**NOTICE OF A REGULAR MEETING
BONDURANT PLANNING AND ZONING COMMISSION
JANUARY 12, 2023**

TITLE: - RESOLUTION NO. PZ-230112-03 considering recommended approval of the Hawthorne Crossing 2 Site Plan/Preliminary Plat

THE CROSSING

THE CROSSING		BONDURANT, POLK COUNTY, IOWA		Sheet C301	
DIMENSION PLAN					
SNYDER & ASSOCIATES, INC.		2727 S.W. SNYDER BLVD ANKENY, IOWA 50023 515-964-2020 www.snyder-associates.com			
Project No: 122.1546.30		Sheet C301

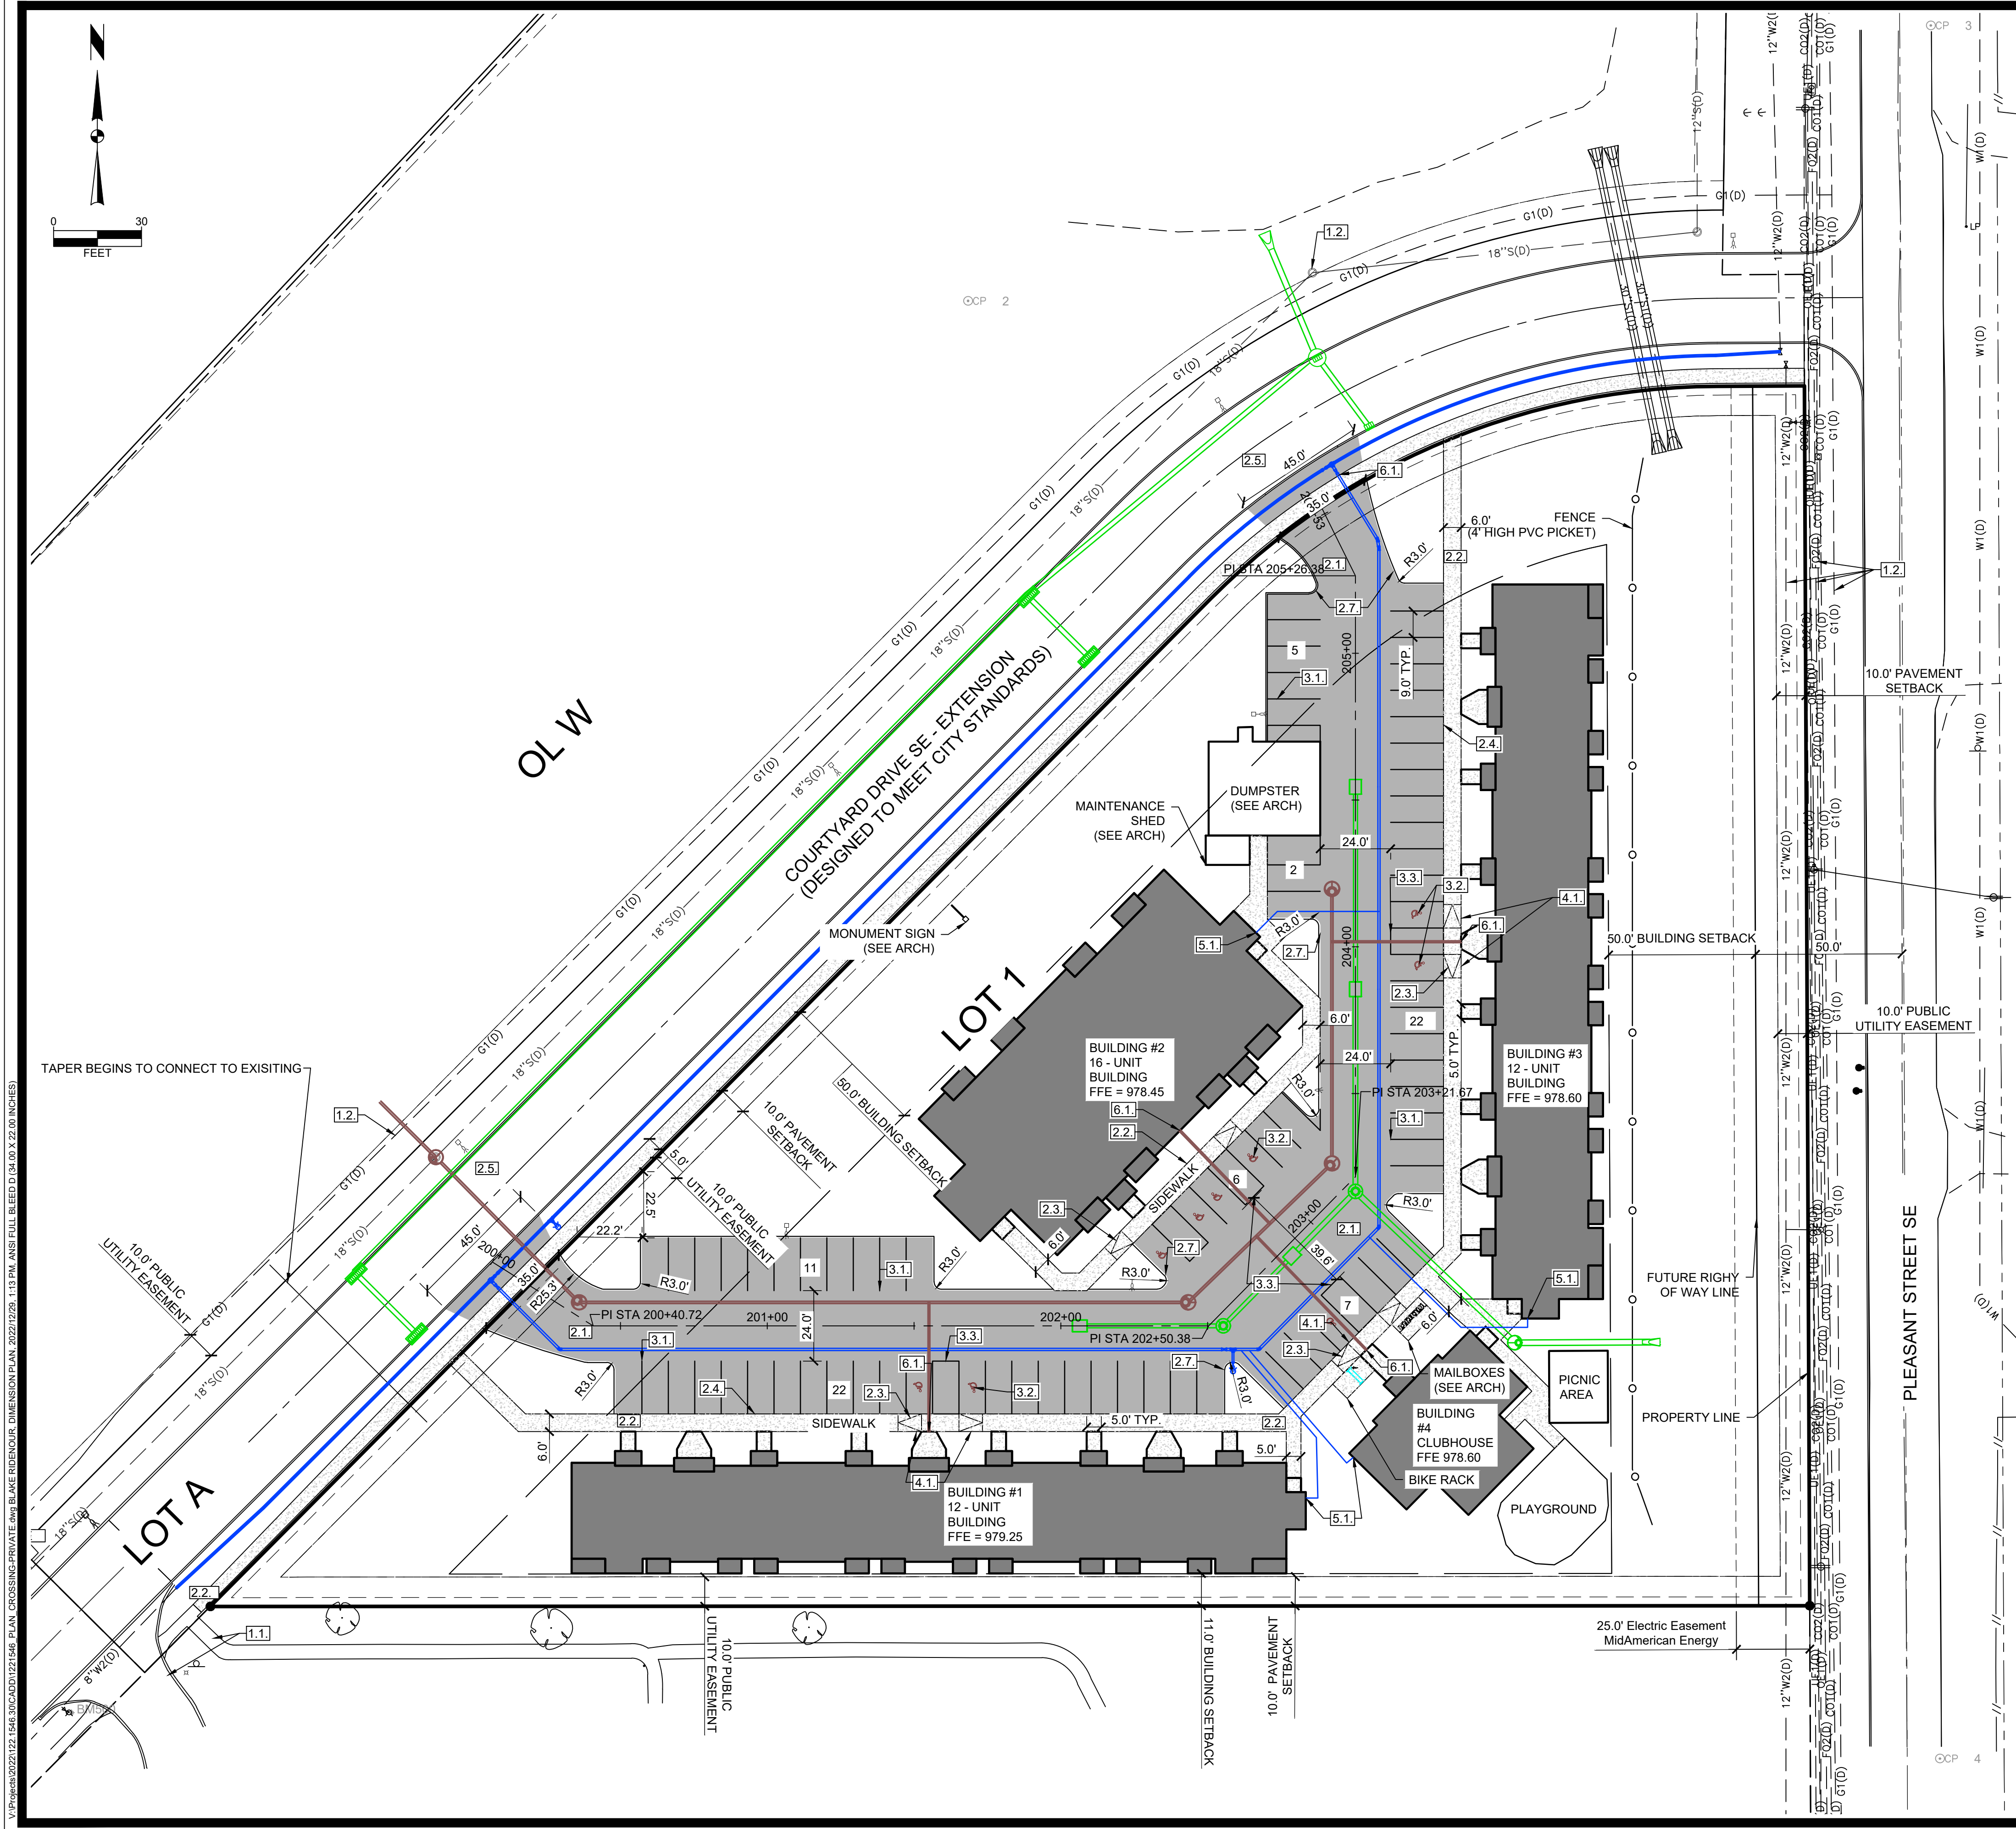
1. Public Works - reviewed and provided the following comments/concerns.
 - Sheet C100 & Sheet C200-Utility contact information is incorrect. Water and sanitary sewer contact information are both:

Project No: 122.1546.30
Sheet EXBT

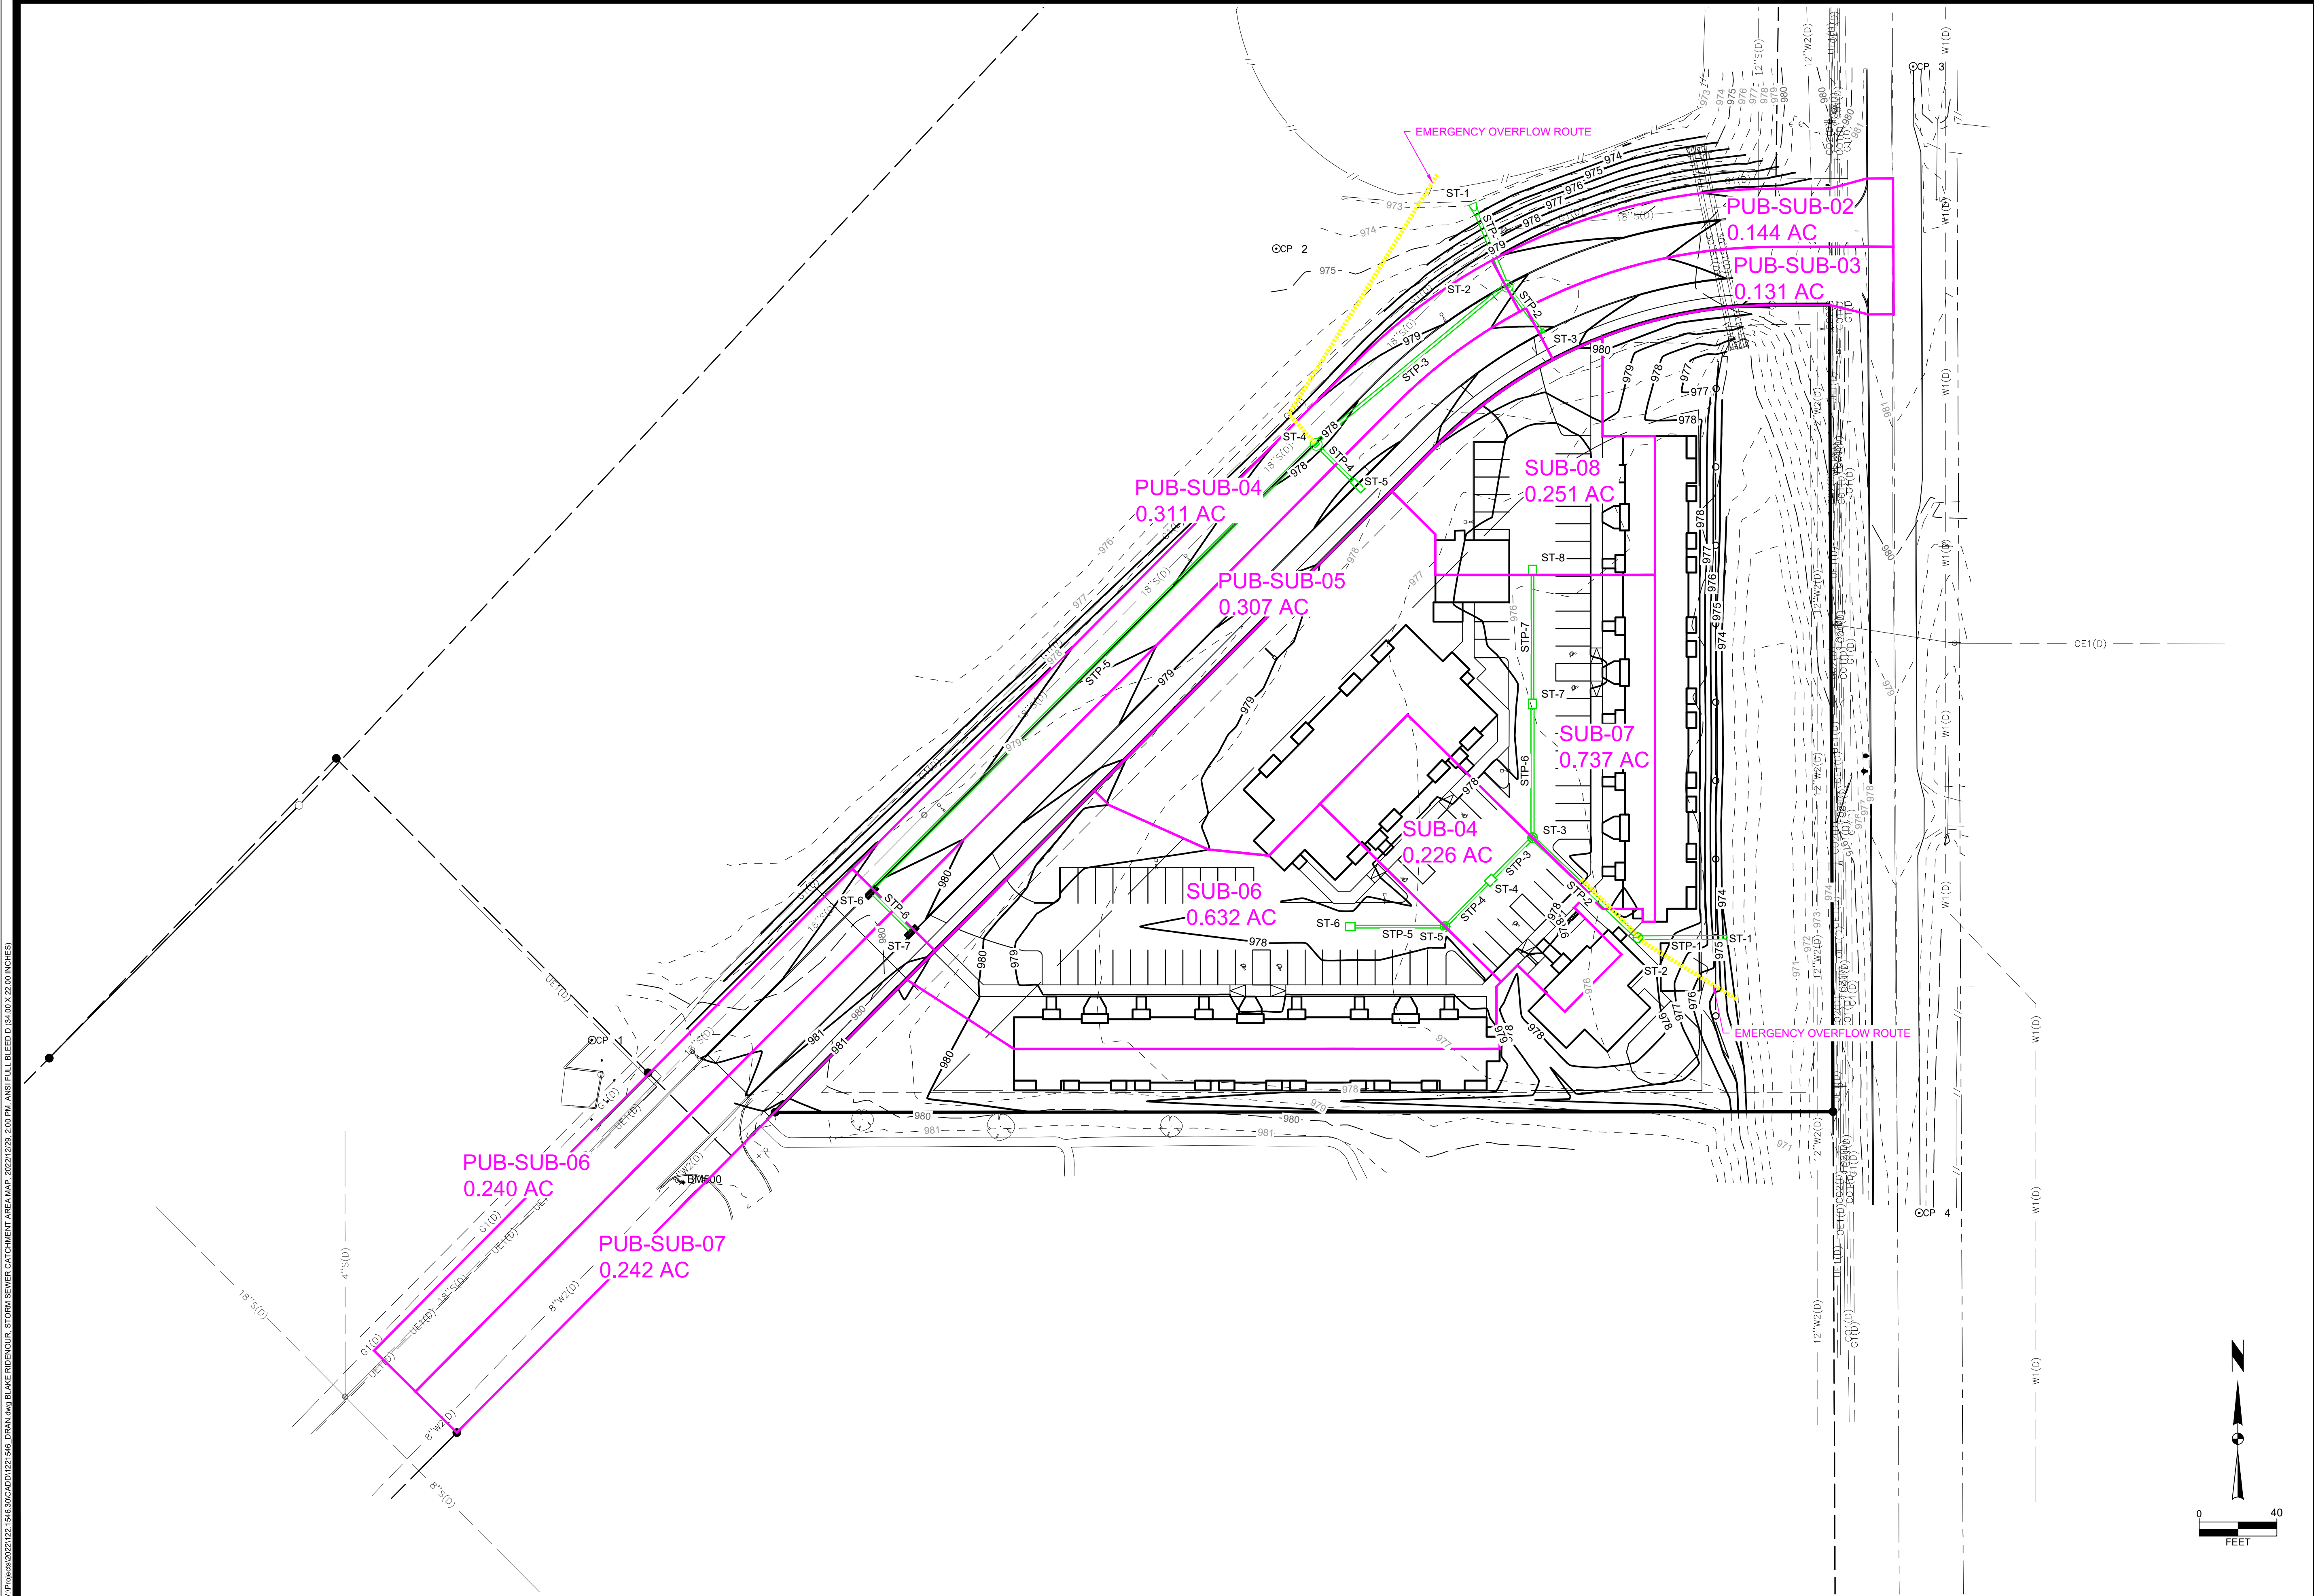
- A stormwater management report has been submitted for review by the City Engineer.
- The site plan should be updated to remove out the ERU reference of 4,000 SF, as this is incorrect.
- Page 8 contains the required utility plan. Sanitary sewer, water, electric and gas are all being extended from existing utility lines along Courtyard Drive SE.
- This site is not located within a water or sanitary sewer connection fee district.
- This site is not situated within FEMA's 100-year floodplain.
- This site is not situated within the City's Stream Buffer Ordinance area.
- Staff commented that any lighting used to illuminate the parking area will be arranged so as to reflect lighting away from any adjacent residential use. This can be accomplished by installing full cut-off lighting. Pages 14-22 address the provided parking lot lighting.
